AP1000 CORE REFERENCE REPORT
DCD (Rev. 19) Change Road Map

Change No.	Chapter 4 Section 4.4	Change Summary Description
[4.4-1]		No change.
[4.4-2]	4.4.1.1.2 paragraph 3	Removed 1.22 and 1.21 DNBR limits to use the single conservative limit of 1.25.
[4.4-3]	4.4.2.1 paragraph 3	Editorial change provided to remove the redundant use of the word "fuel" from the sentence.
[4.4-4]	4.4.2.2.1 paragraph 4	The statement is revised to add new References for correlations ABB-NV (References 89 and 90) and WLOP (Reference 90) which replace W-3 (References 5 and 6). Reference 5 is retained in the list of References since it is continues to be referenced by Section 4.4.2.2.2. Reference 6 is deleted as no longer used.
[4.4-5]	4.4.2.2.1 paragraphs 7 and 8	The description is revised to remove two paragraphs previously related to W-3 and to replaced them with a description of the application of ABB-NV and WLOP.
[4.4-6]	4.4.2.2.2, paragraph 2	The paragraph is revised to replace the description of the W-3 application with a summary note to state that adjusted F factors are used for WRB-2M, ABB-NV, and WLOP (References 82a, 89, and 90, respectively).

4.4 Thermal and Hydraulic Design

Figure 4.4-2

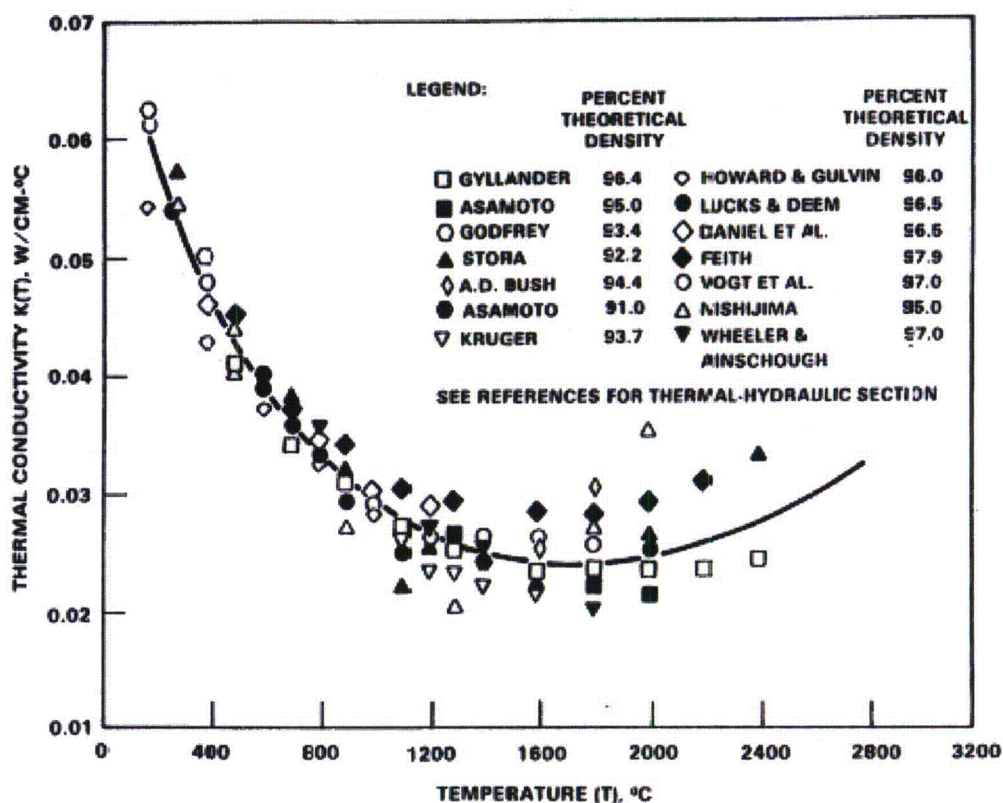
[4.4-17]	Table 4.4-1, Sheet 1 of 2	Editorial change is provided to correct "System pressure, minimal" with "System pressure, minimum".
[4.4-18]	Table 4.4-1, Sheet 1 of 2	Revised the AP1000 DNBR to reflect the advanced first core.
[4.4-19]	Table 4.4-1, Sheet 1 of 2	Removed ">1.22" and ">1.21" for AP1000 DNBR consistent with the change to sub-section 4.4.1.1.2.
[4.4-20]	Table 4.4-1, Sheet 2 of 2	Updated AP1000 core and vessel pressure drops due to implementation of AP1000 grid design.
[4.4-21]	Table 4.4-1, Note (b)	Removed DNBR limits of 1.22 and 1.21 consistent with the change to sub-section 4.4.1.1.2.
[4.4-22]	Table 4.4-1, Note (c)	Replaced W-3 correlation with ABB-NV and WLOP correlations.
[4.4-23]	Table 4.4-2	Revised the calculated void fraction to correspond to the Advanced First Core $F_{\Delta H}^N$ value of 1.72/1.04
[4.4-24]	Figure 4.4-2	Replaced Figure 4.4-2 because the units on the y-axis in DCD Rev 19 were incorrect.

Comment [A23]: [4.4-24]
